TECHNICAL BULLETIN

MOTORCYCLE
M6-040

650CC TWIN
CYLINDER HEAD COVER AVAILABILITY

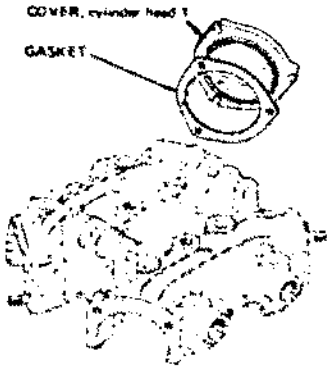
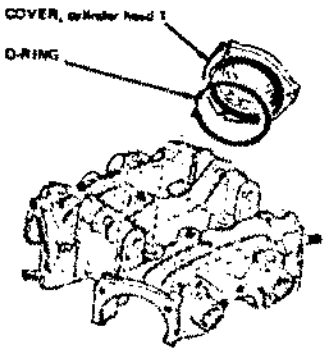
Original cylinder head side covers for XS1s, XS2s, TX650s, TX650As and XS650Bs are no longer available. The original side covers have been replaced by XS650C covers (447). When replacing an original side cover with the 447 cover, a new 932 style o-ring must be used.

Page	Ref. No.	Original Part No.	New Part No.	Description	Qty.						Remarks
					XS1	XS1B	XS2	TX650A	XS650A	XS650B	
4	13	256-11186-00-00	447-11186-00-00	COVER, cylinder head side 1	4	4	3	3			Combined parts book
4	19	256-11196-01-00 (gasket)	93210-82304-00 (o-ring)	O-RING(2.8-62)	4	4	3	3			Combined parts book
2	14	256-11186-00-00	447-11186-00-00	COVER, cylinder head side 1					3	3	XS650B use "A" parts book
2	15	256-11186-01-00	93210-82304-00	O-RING(2.8-62)					3	3	XS650B use "A" parts book
